Addendum No. 04

**Replace HVAC System, Waggoner Building
General Headquarters Complex
Jefferson City, MO
PROJECT NO. R2411-01**

A-702 – DEMO AND NEW RCP AT WAGGONER BLDG. – 2ND FLOOR

1 SECOND FLOOR DEMO RCP

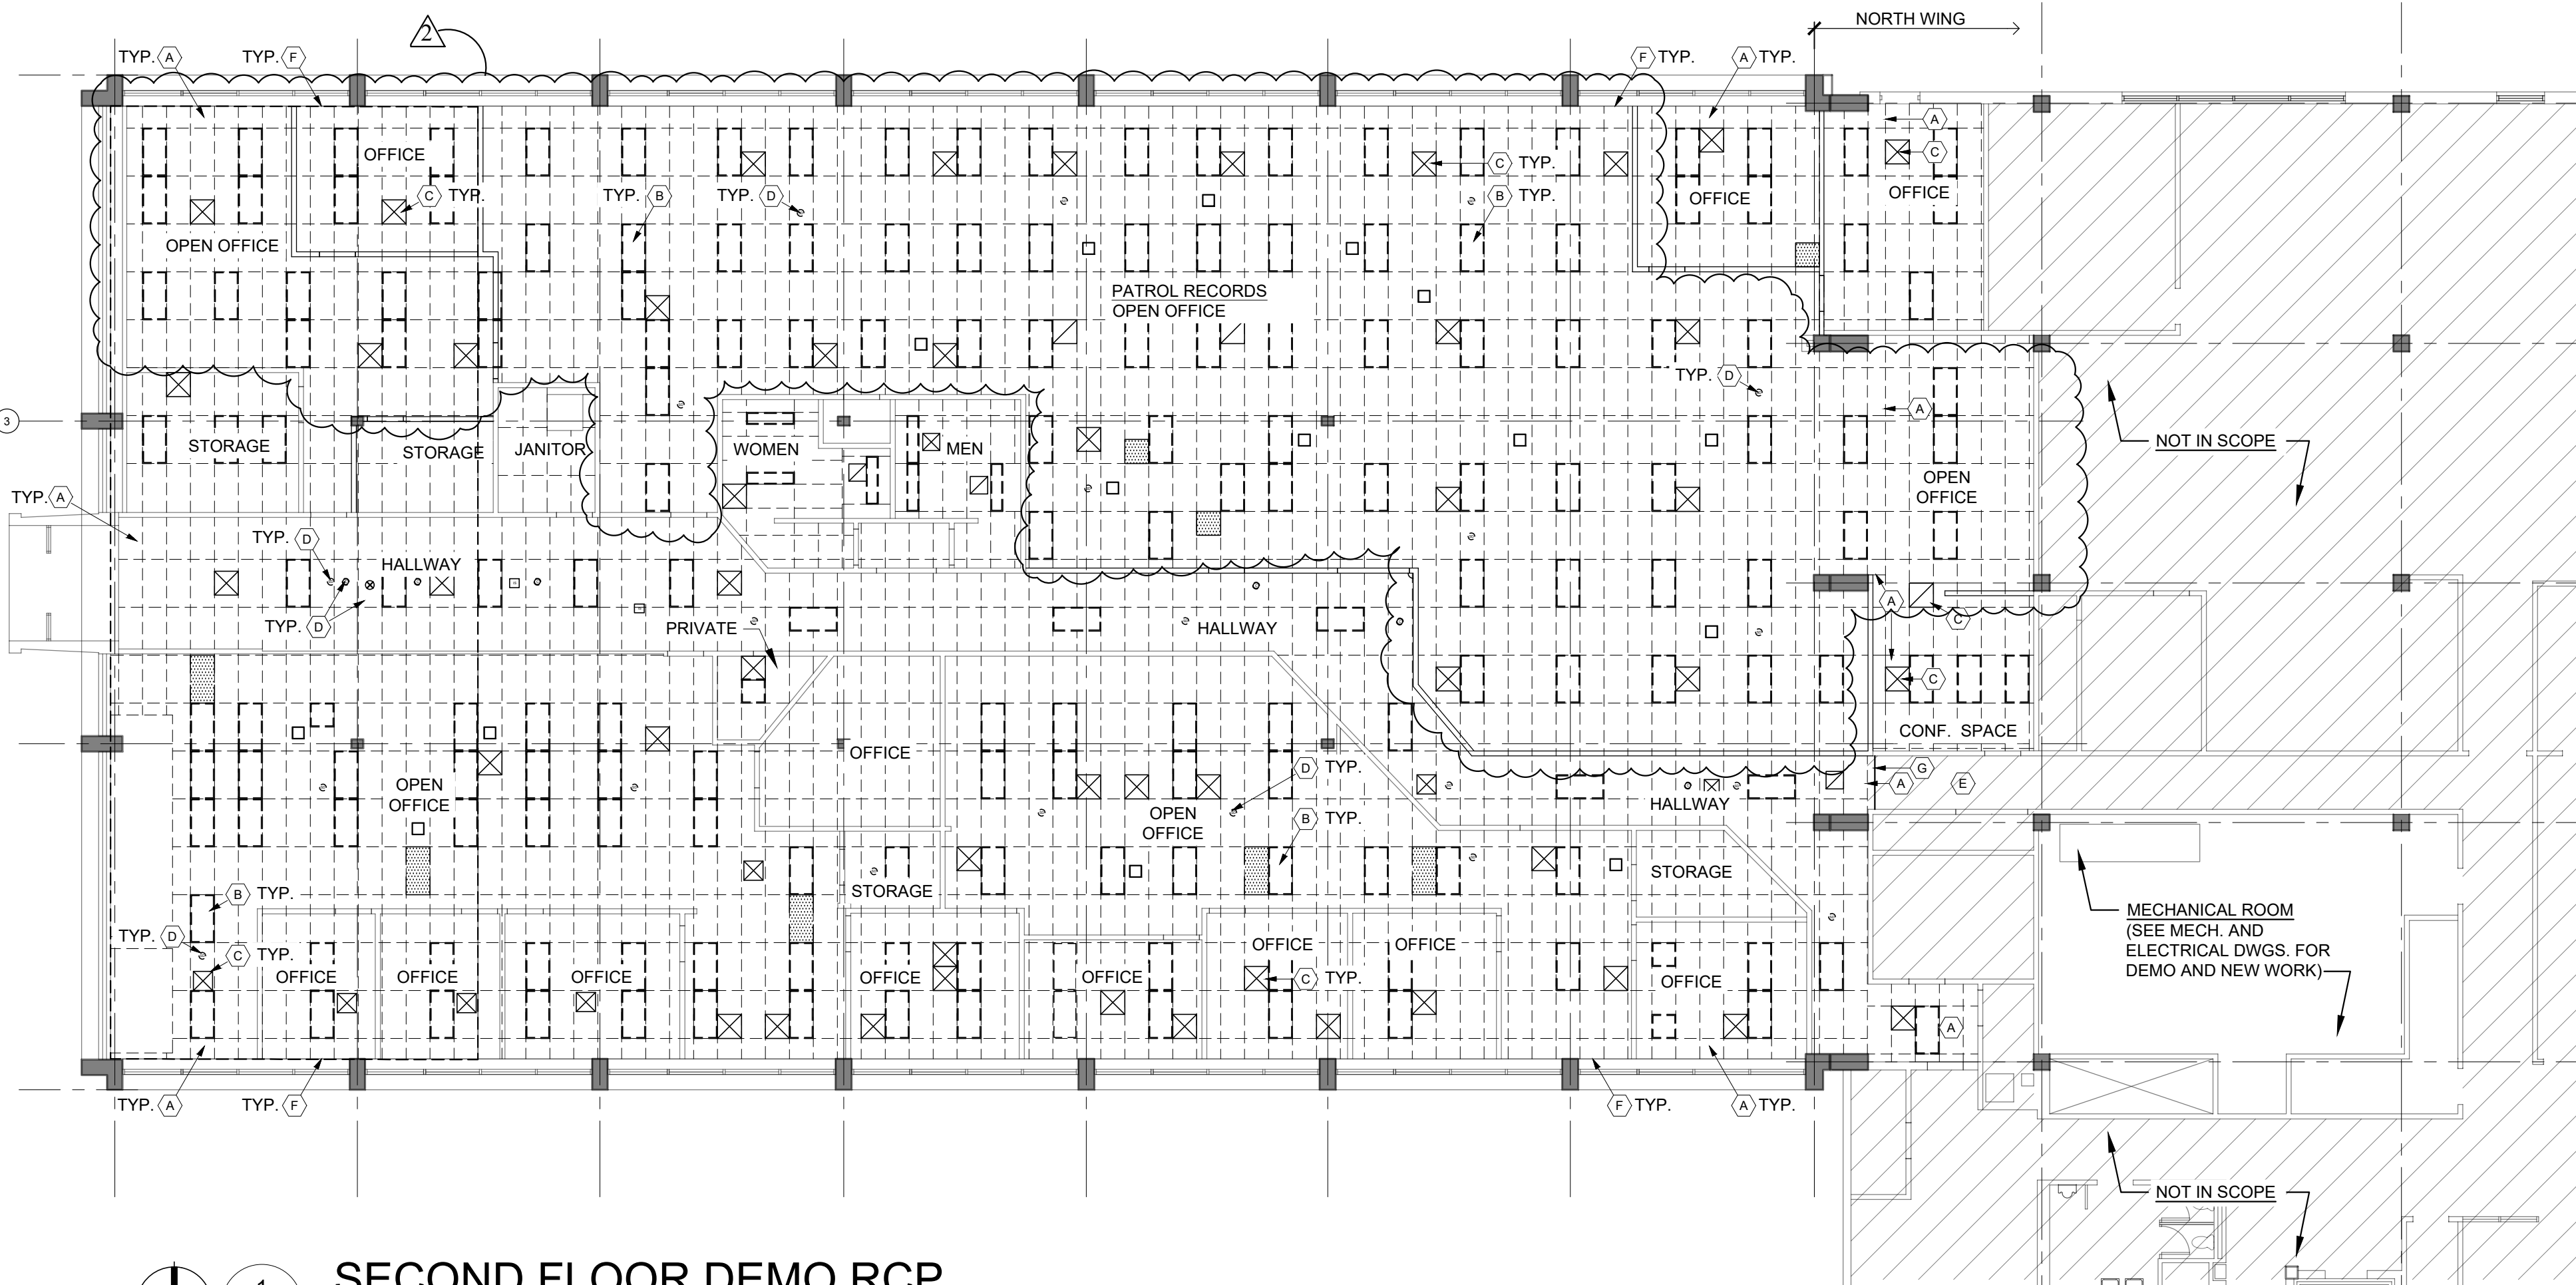
ADD: DETAIL 1 – “PATROL RECORDS” room tag

2 SECOND FLOOR RCP

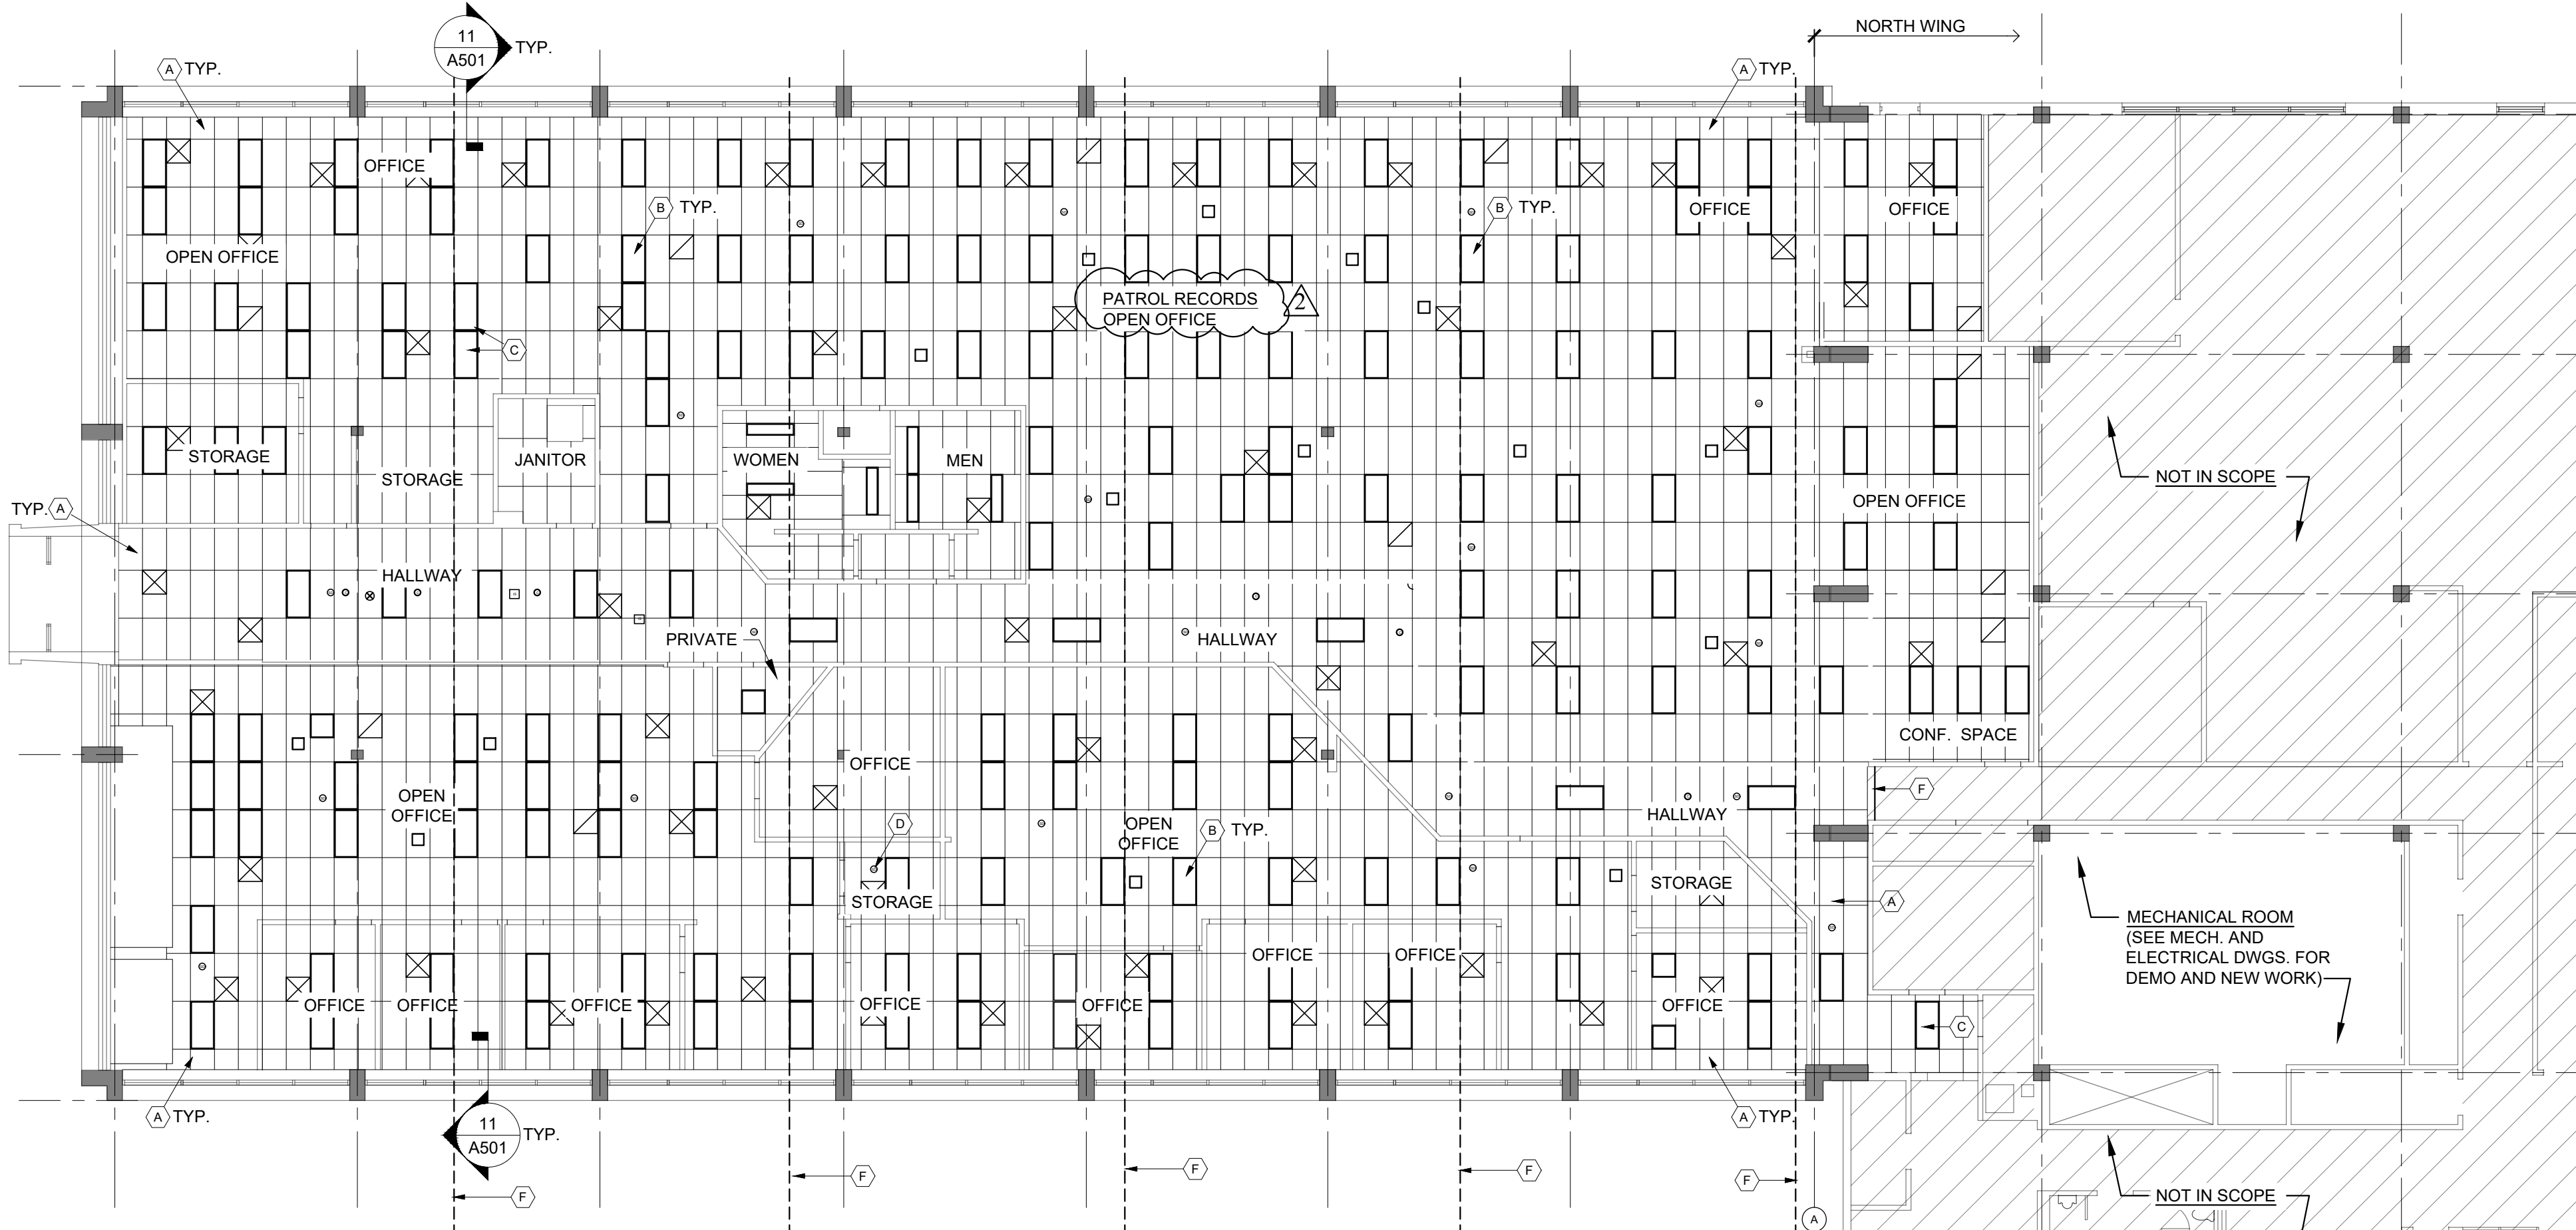
ADD: DETAIL 2 – “PATROL RECORDS” room tag
